**HVAC Replacement for
Summit Drive Elementary School
Greenville County School District**

Solicitation No: **124-33-9-29**

Addendum No. 2

DATE: October 12, 2023

A-110

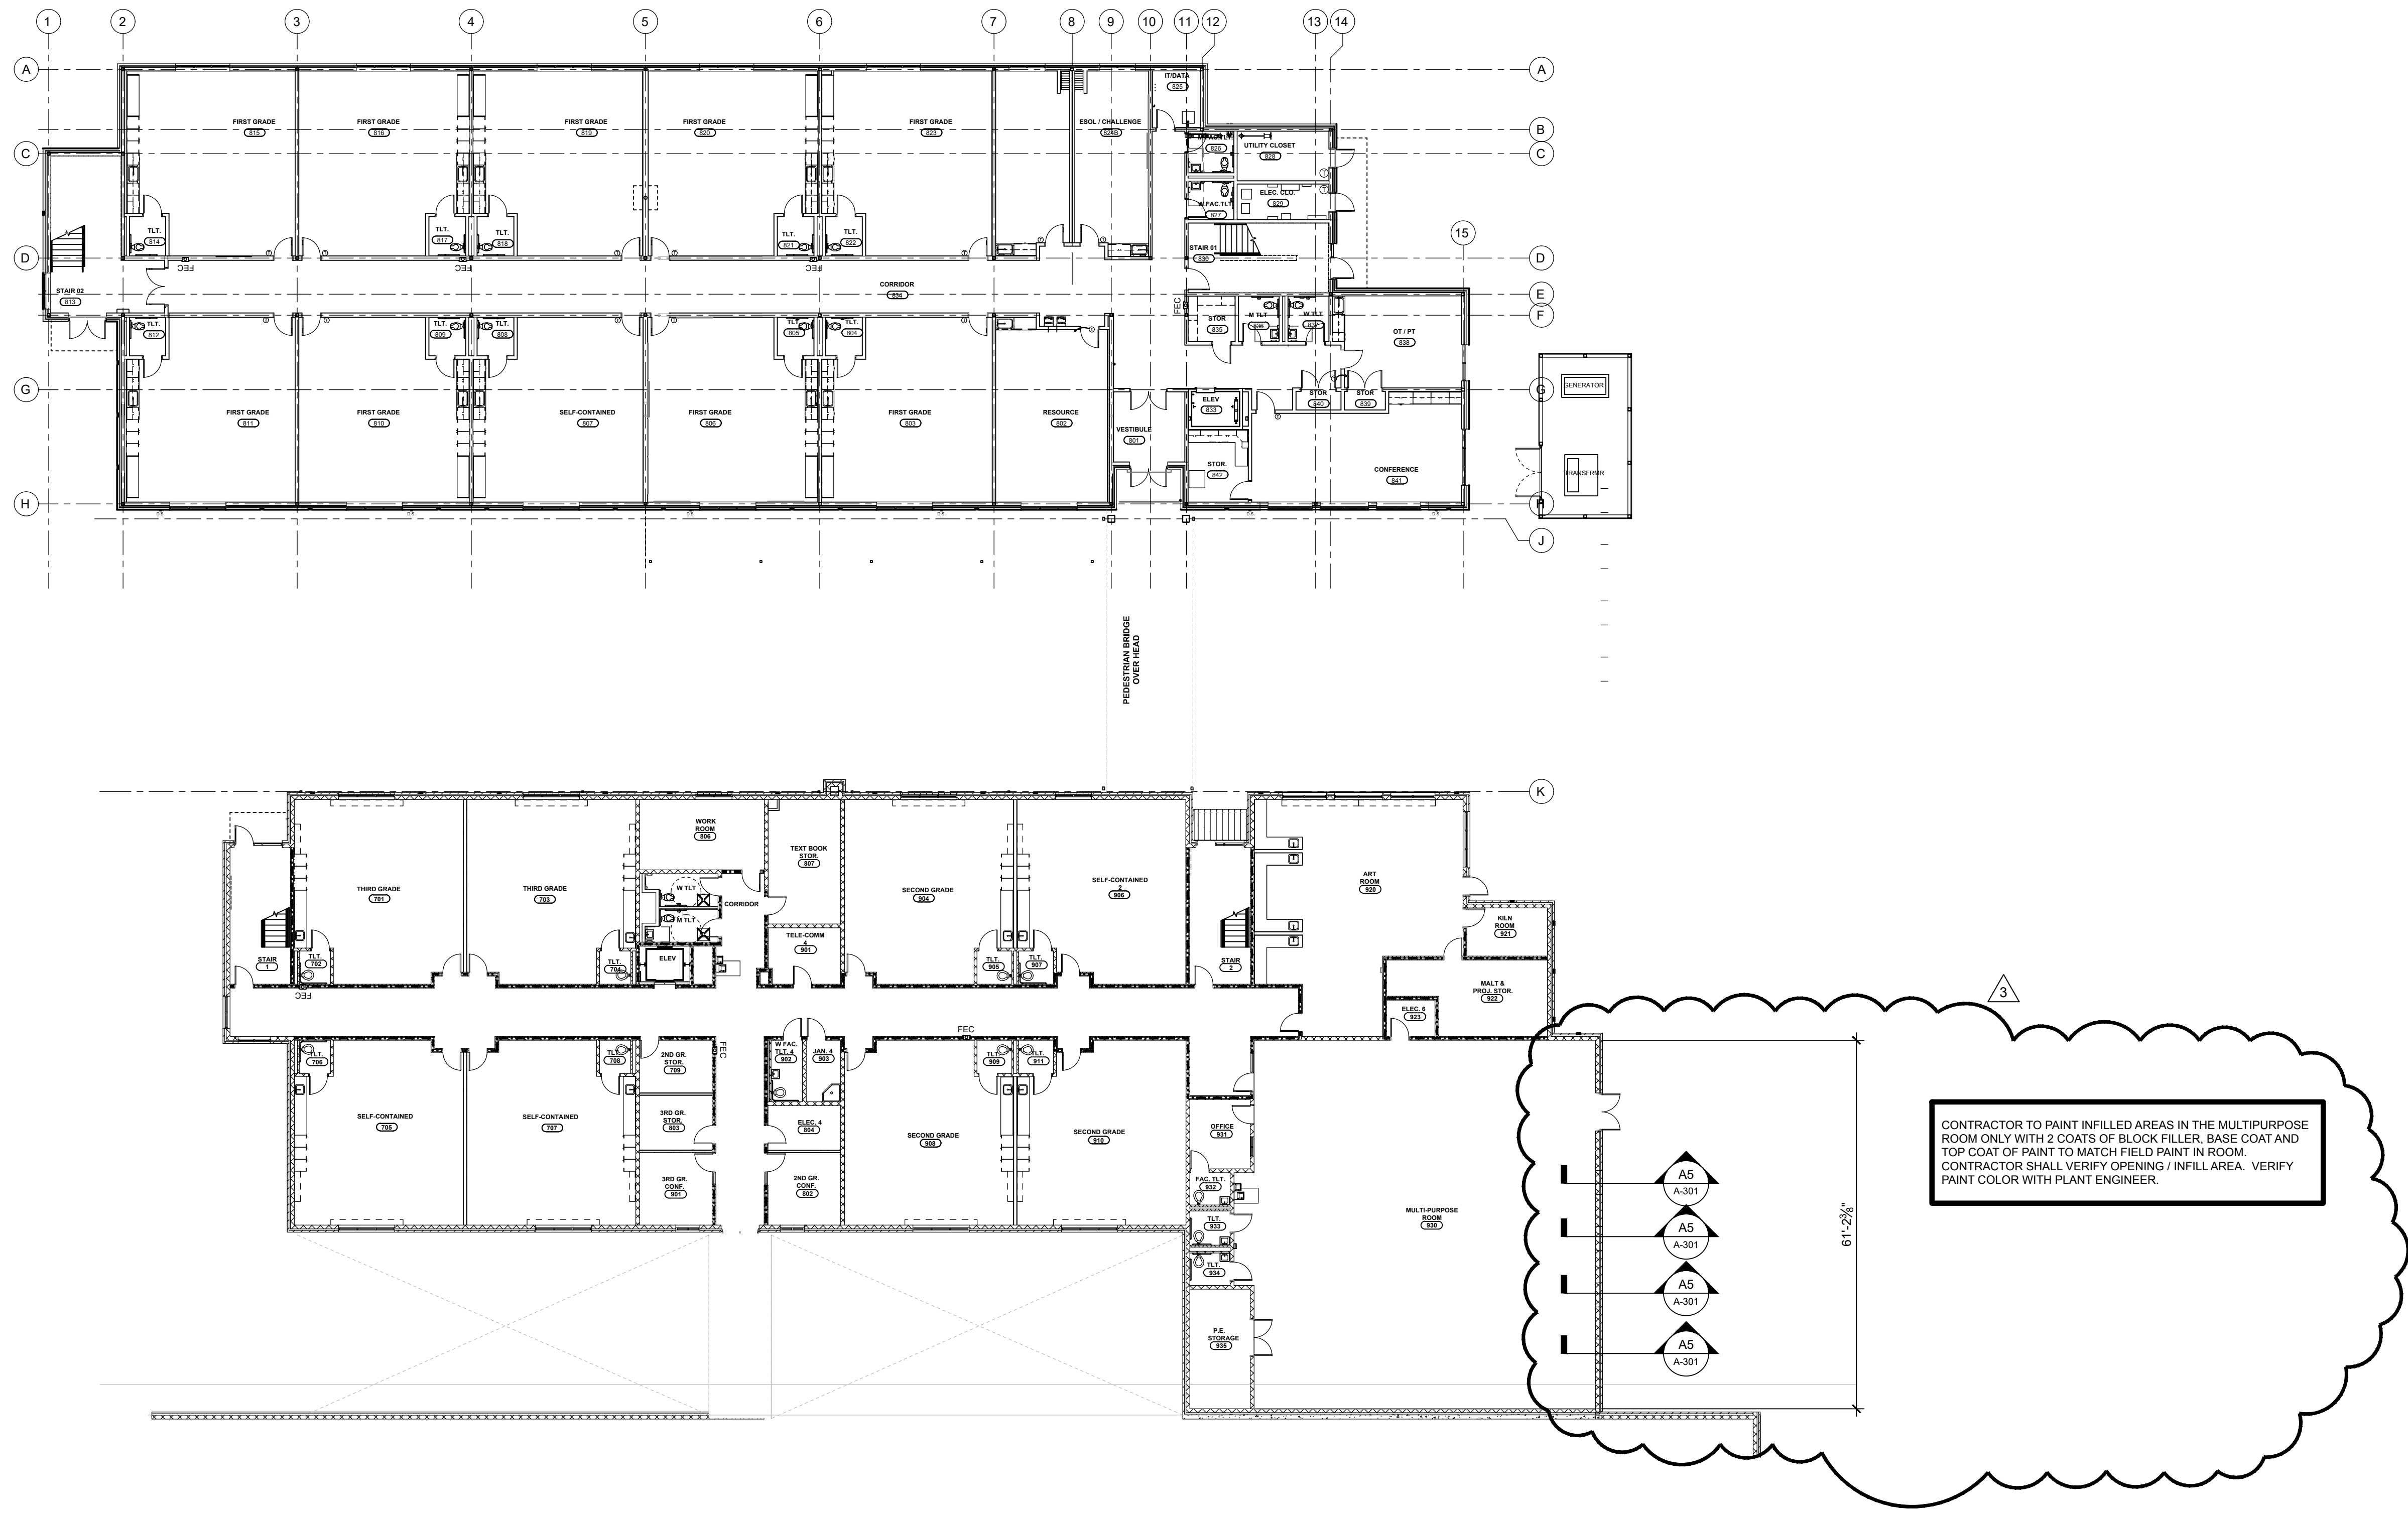
1. A-110, Overall Lower Level Floor Plan, Added note regarding scope of wall painting as well as added multiple references to A-301 wall sections.
2. A-301, Sections, Added clarification notes regarding wall painting and wall infill.
